# 1962 Corvette: Service Bulletin: Aluminum Powerglide Shift Problems

**Model and Year:** 1962 Passenger, Chevy II and Corvette

**Bulletin No:** DR #514

**Date:** January 16, 1962

FIGURE 1- 327 AND 283 POWERGLIDE TV LINKAGE COMPARISON

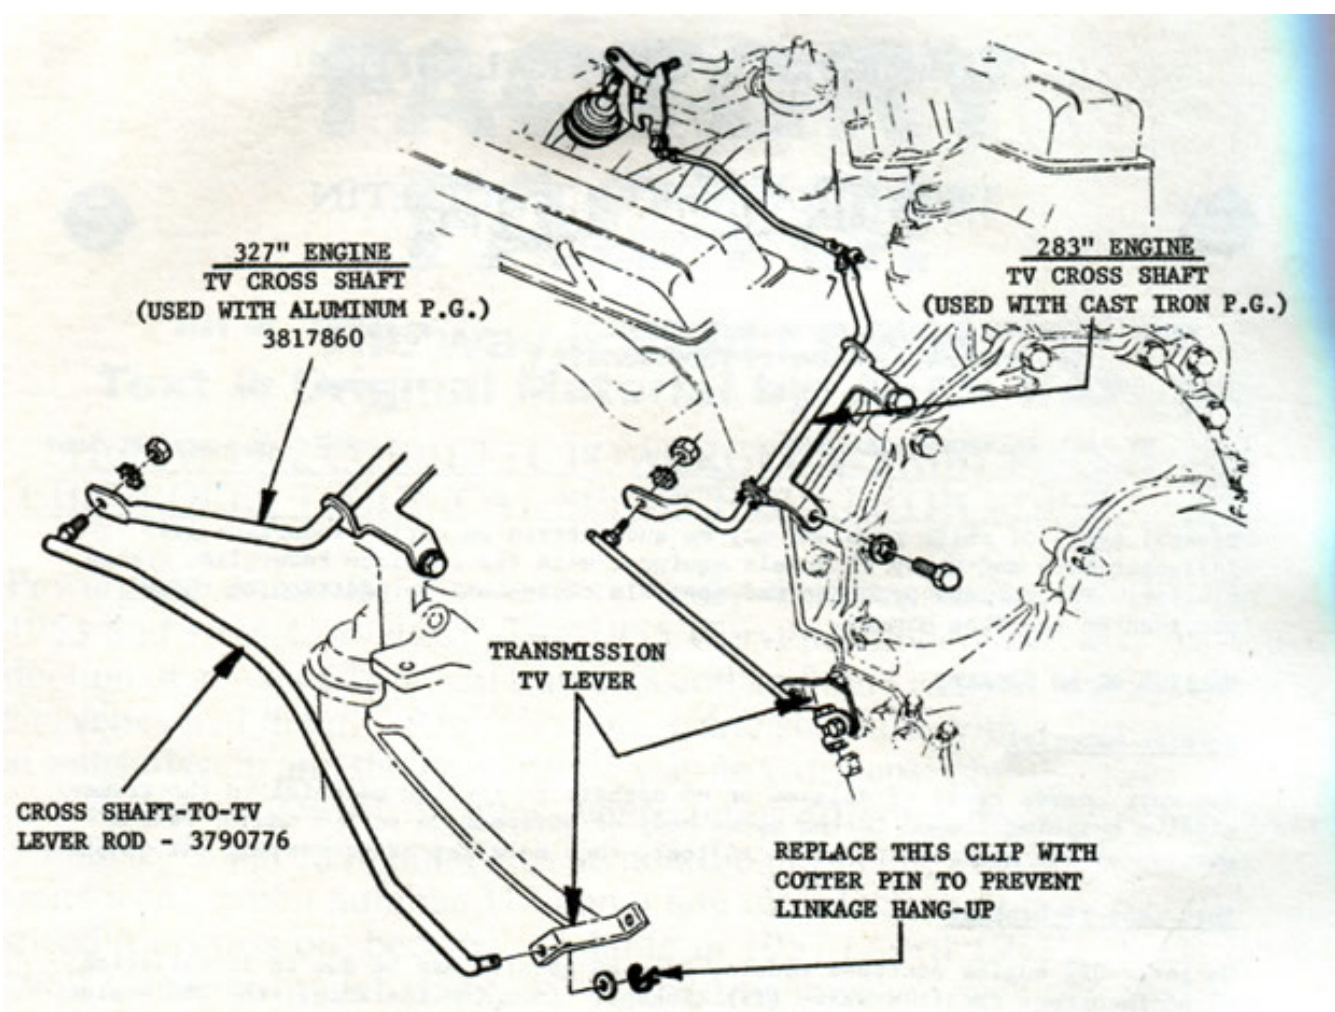
On early 327 engine equipped models, delayed upshift may be due to installation of an incorrect throttle valve (TV) linkage. In a few instances, the 283 engine cross shaft was installed instead of the correct TV cross shaft, 3817860. The TV cross shaft are easily identified as the 283 version has a bend in its outboard lever whereas the 327 cross-shaft lever is straight in this same area. (Figure 1). If the TV cross shaft was incorrect, also check the cross shaft-to-TV lever rod. As shown in Figure 1, this rod, 3790776, is formed on 327 engine applications as compared to the straight rod used on 283 engine versions.

Cross Shaft, TV (327 engine) ---- 3817860

Rod, Cross Shaft-to TV (327 engine) ----- 3790776

FIGURE 2 - ALUMINUM POWERGLIDE DIPSTICKS

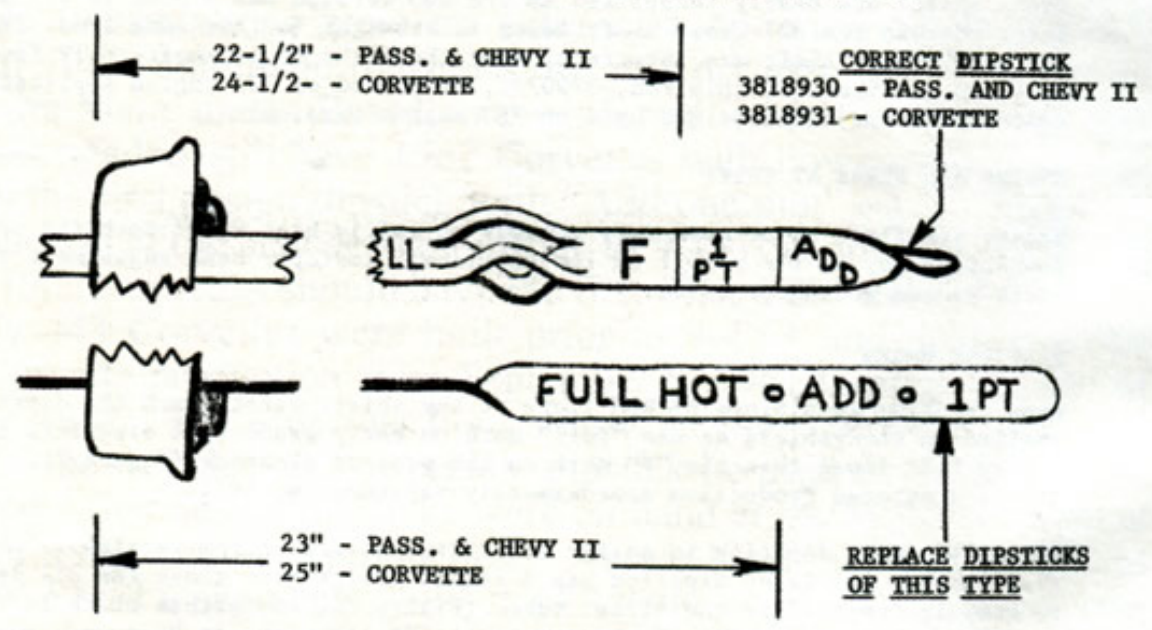
When checking complaints of RPM flare at the shift, first check the dipstick installed in the vehicle as the "Full" mark on early production dipsticks is approximately 1/2" lower than the "F" mark on the present dipstick (Figure 2). The later dipstick entered Production approximately September 4, 1961.

The early style dipstick is easily identified as its bottom section is absolutely flat whereas the later dipstick has a formed bridge just above the oil level markings to keep it centered in the filler tube. (Figure 2). A further check is to measure the distance from the top of the cap to the "Full" mark; on

Passenger and Chevy II dipsticks, this distance is now 22-1/2", as compared to 23" on the earlier dipsticks. This distance on the Corvette dipstick is now 24-1/2" as compared to 25" on earlier units.

Replace all early dipsticks with the later part when found and add oil as

required to raise the transmission oil level to the "F" mark. The later dipstick for 327 engine passenger cars and all Chevy II Models is 3818930; for Corvette, 3818931.
